# HISTORIC AND DESIGN REVIEW COMMISSION

**HDRC CASE NO:** 2022-056  
**ADDRESS:** 555 S ALAMO ST  
**LEGAL DESCRIPTION:** NCB 901 BLK LOT 44, 45 & 46  
**ZONING:** D, H, RIO-3  
**CITY COUNCIL DIST.:** 1  
**DISTRICT:** La Villita Historic District  
**APPLICANT:** James McKnight/Brown & Ortiz, PC  
**OWNER:** Eric Stone/AUTO HOTEL LLC  
**TYPE OF WORK:** Construction of a fitness center, construction of accessory structures, site modifications,  
**APPLICATION RECEIVED:** January 14, 2022  
**60-DAY REVIEW:** Not applicable due to City Council Emergency Orders  
**CASE MANAGER:** Edward Hall

**Historic and Design Review Commission**  
***Design Review Committee Report***

06 FITNESS CENTER - OVERALL E/W BUILDING SECTION  
3/16" = 1'-0"

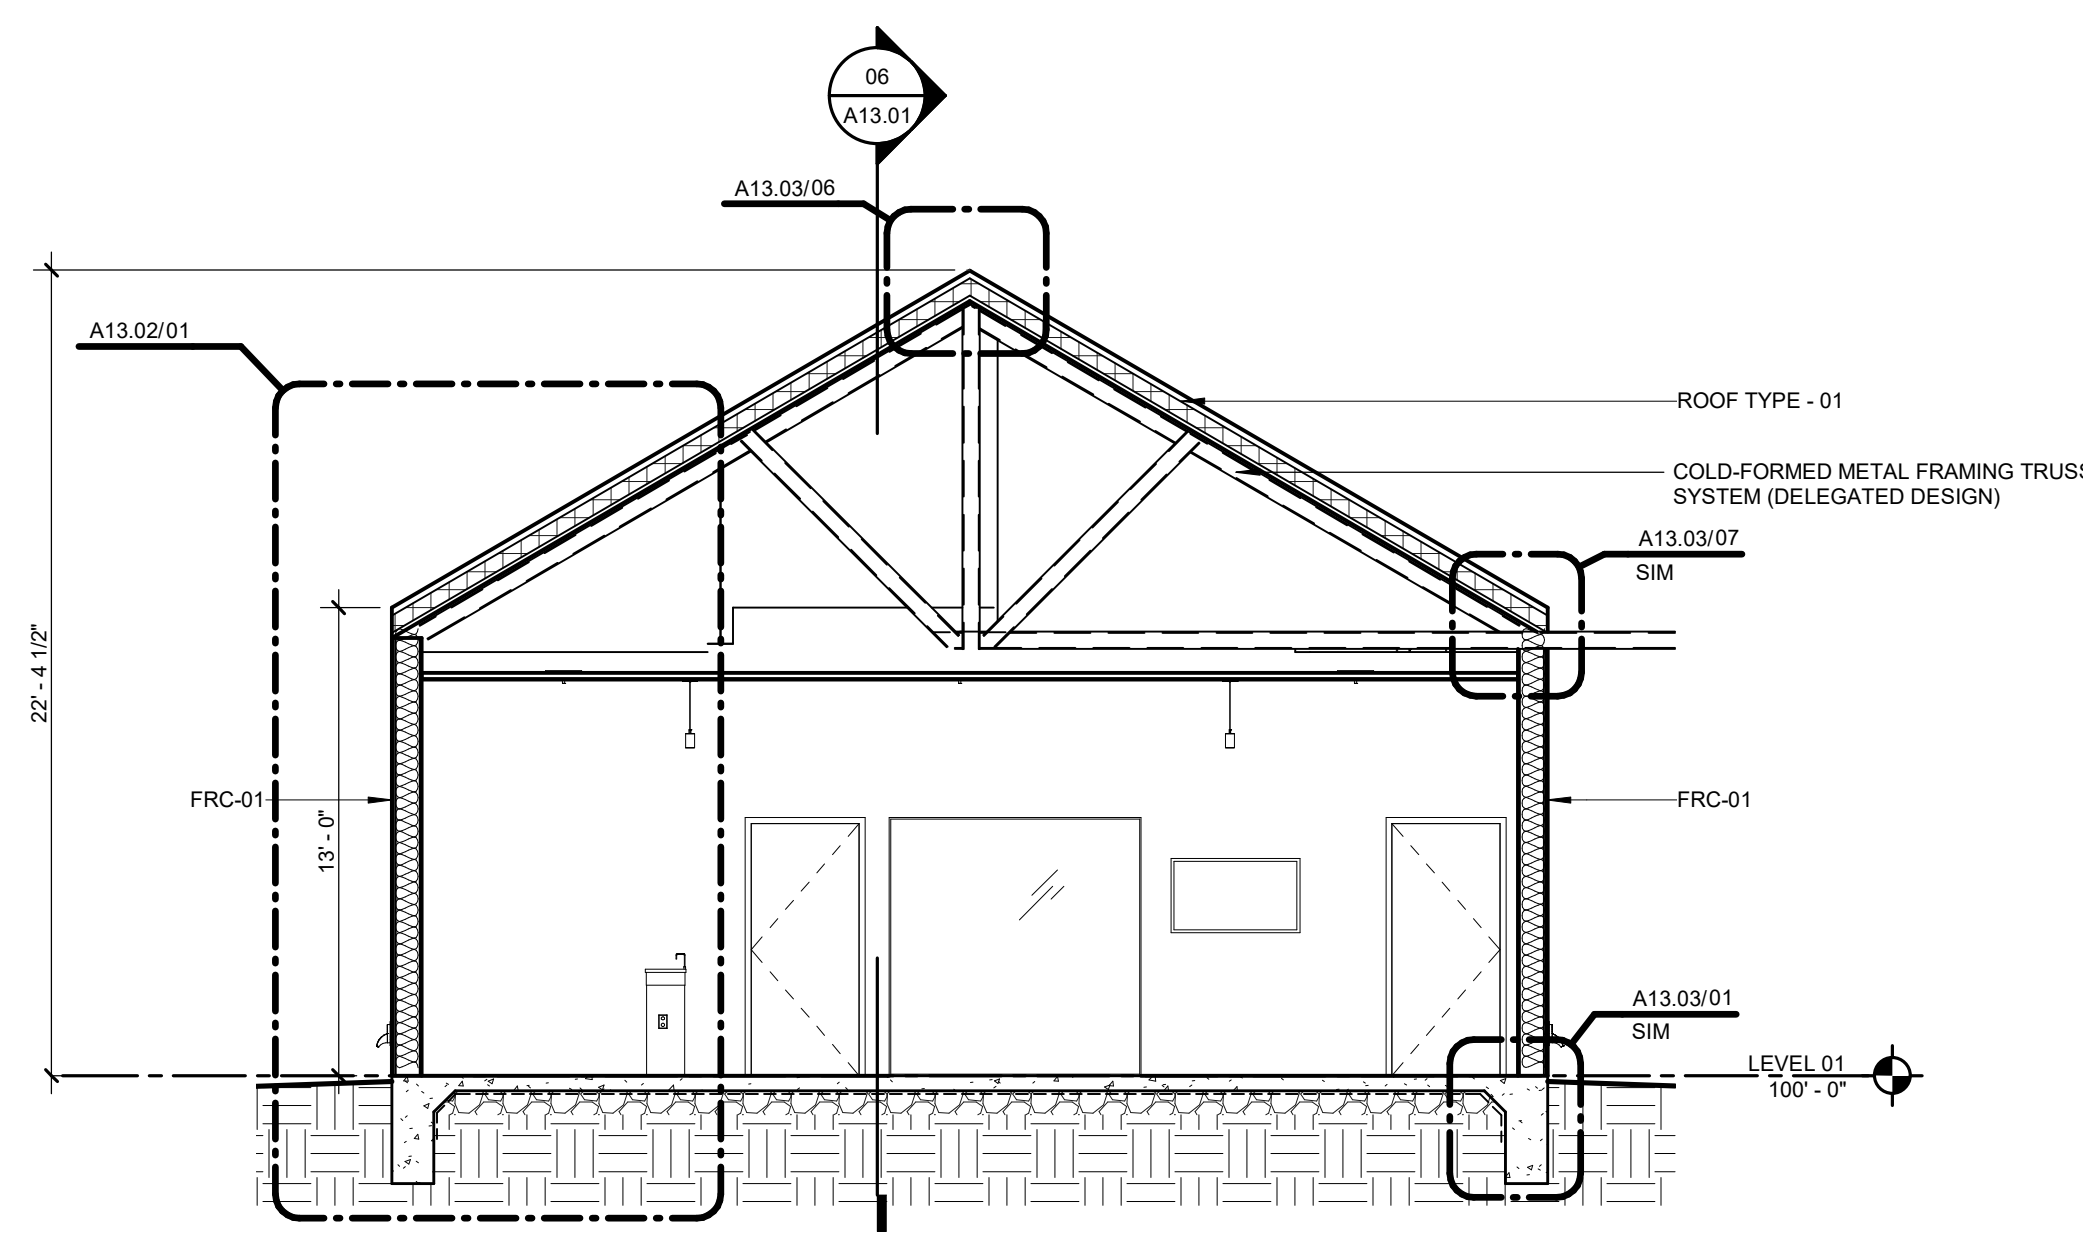
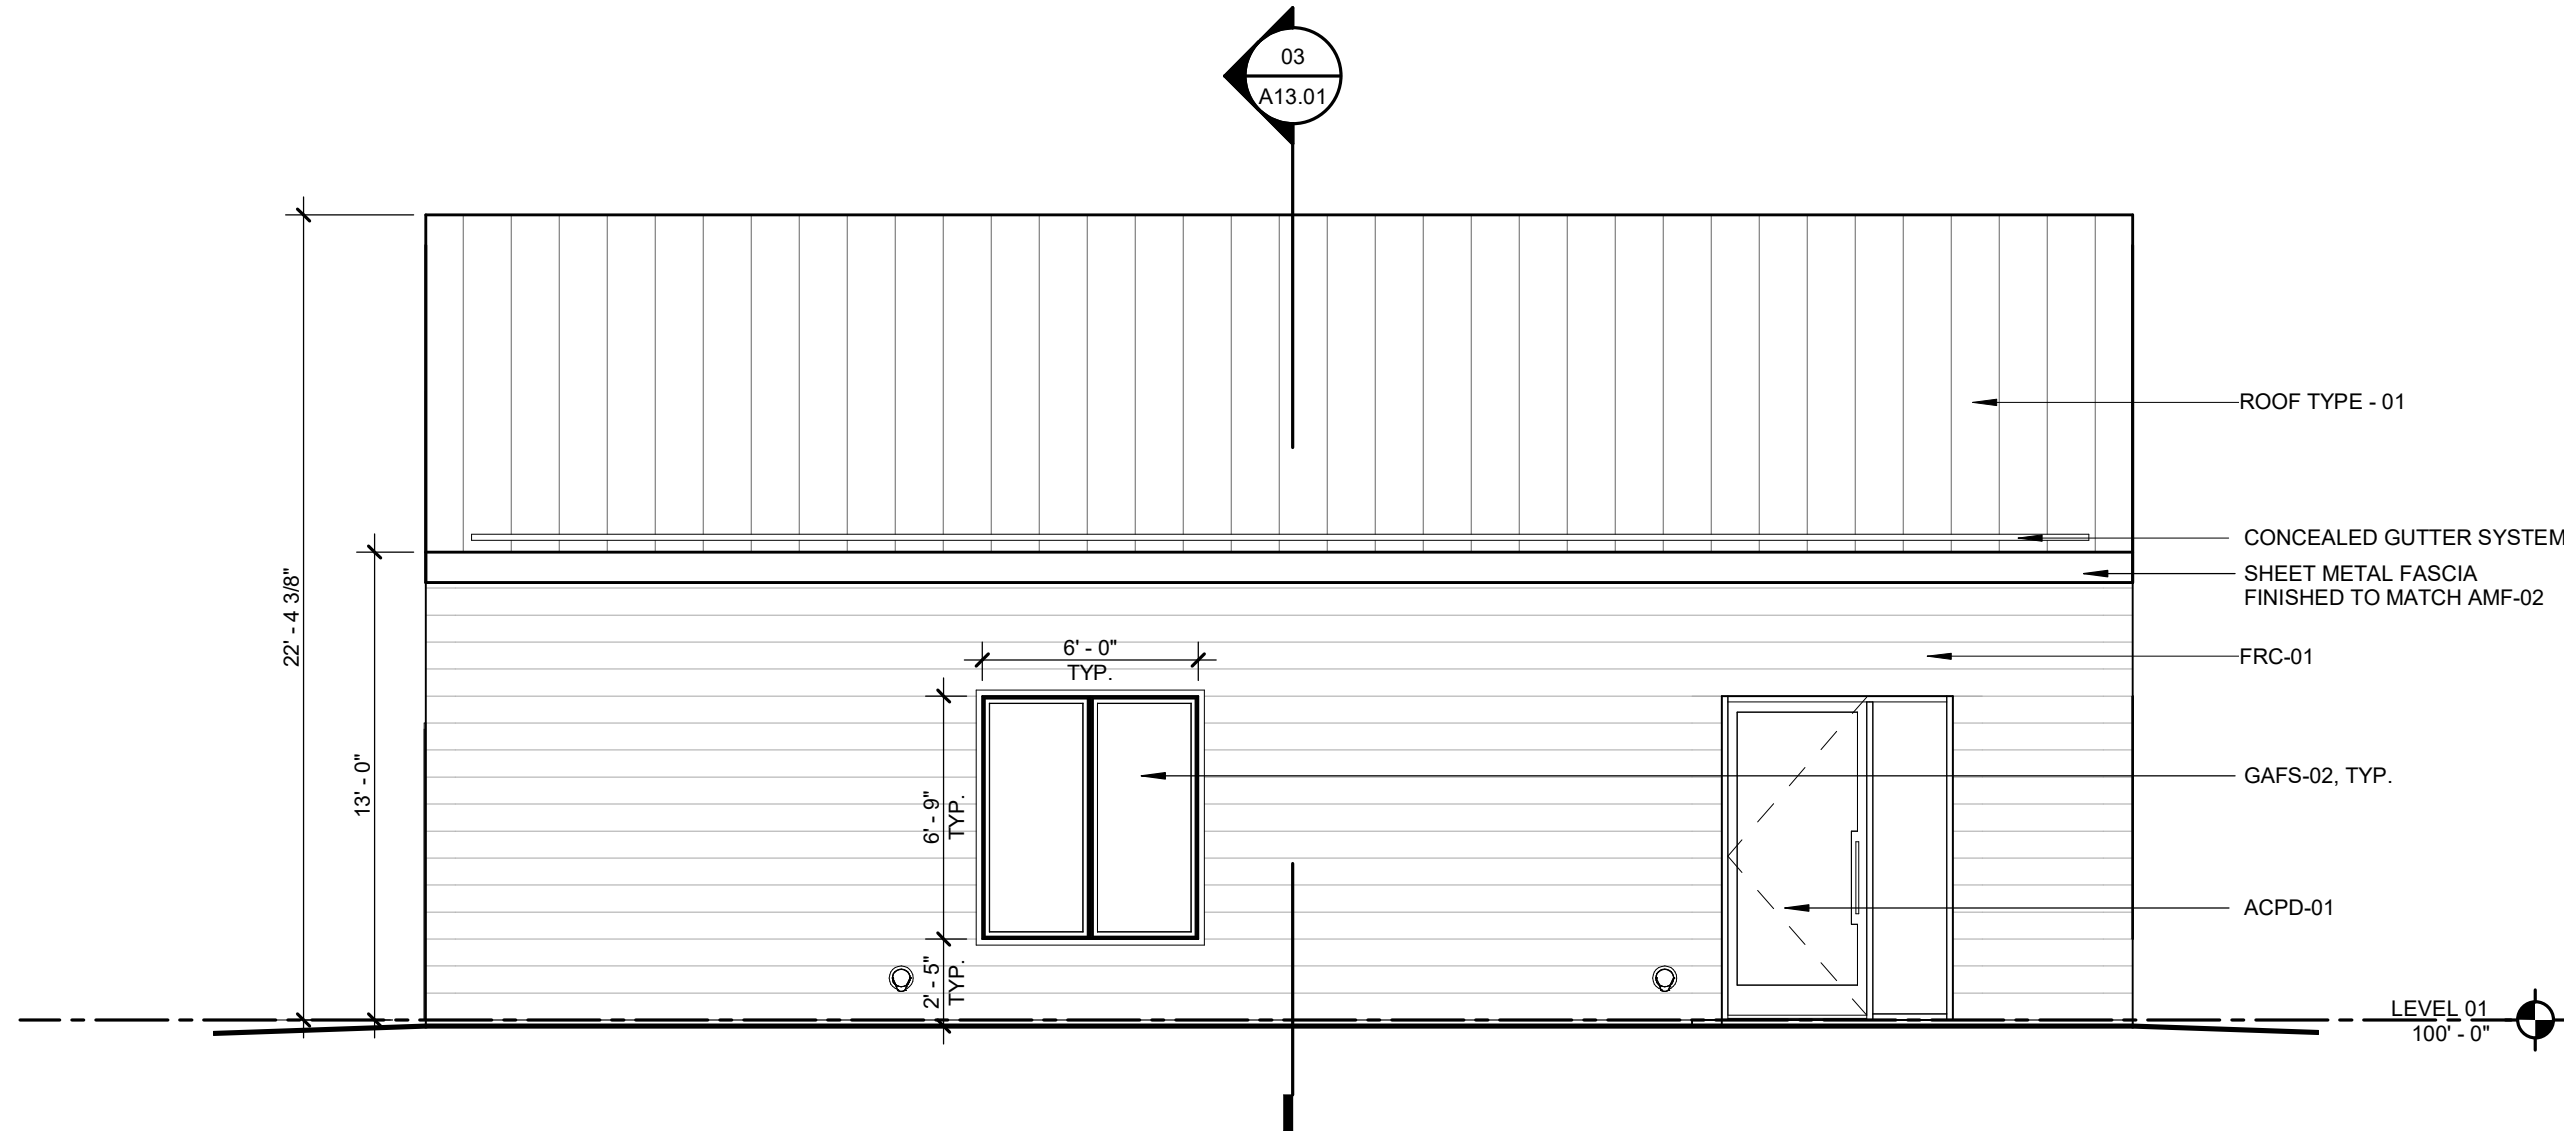
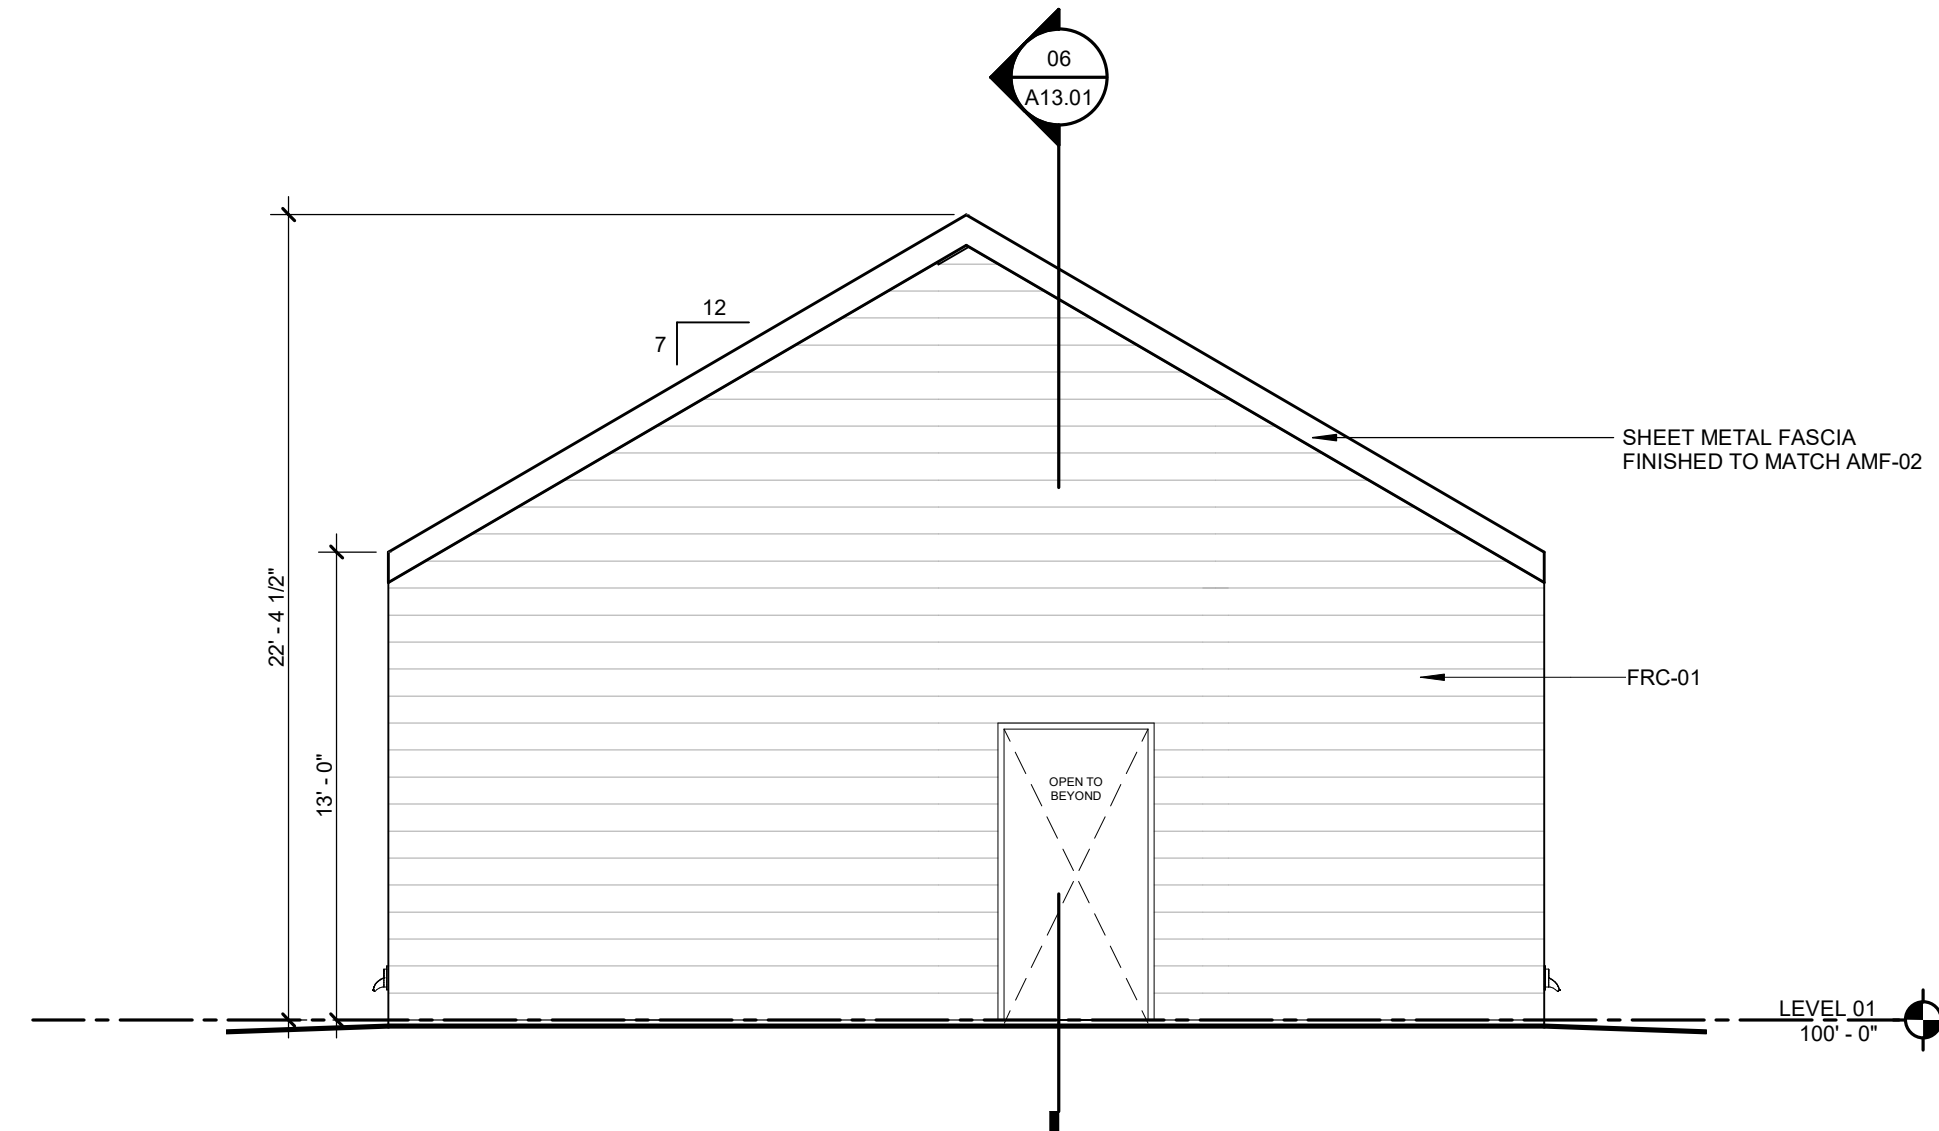
- g. **FITNESS CENTER (Setback)** – The applicant has proposed a setback on S Presa that is greater than that of the adjacent Staffel House. Staff finds the proposed setback to be appropriate and consistent with the Guidelines.

- h. **FITNESS CENTER (Materials)** – The applicant has proposed materials for the fitness center that include standing seam metal roof, composite wood panels feature a smooth finish and horizontal profile and metal windows and doors. Staff finds that the proposed standing seam metal roof should feature panels that are 18 to 21 inches wide, seams that are 1 to 2 inches in height and a crimped ridge seam. A low profile ridge cap may be submitted for review and approval by the Commission for new construction. Generally, staff finds the proposed zinc finish for the metal roof to be appropriate as it is comparable in color to the standard galvalume finish. The composite siding should feature a four (4) inch exposure.

- i. **WINDOWS** – The applicant has proposed to install metal windows that will feature dark frames and be recessed two inches within wall openings. Staff finds this to be appropriate.

MS: Questions about the general design of the fitness center. Has the setback been increased? ZJ: Yes, the setback has been increased eight feet, the depth of the porch of the historic structure.

- 1. Staff recommends approval of item #1, the construction of an event structure as submitted based on finding d.
- 2. Staff recommends approval of item #2, the construction of a pool structure as submitted based on finding e.
- 3. Staff recommends approval of item #3, the construction of a fitness structure based on findings f through j with the following stipulation:
  - i. That the proposed composite siding feature a smooth finish and an exposure of four (4) inches.
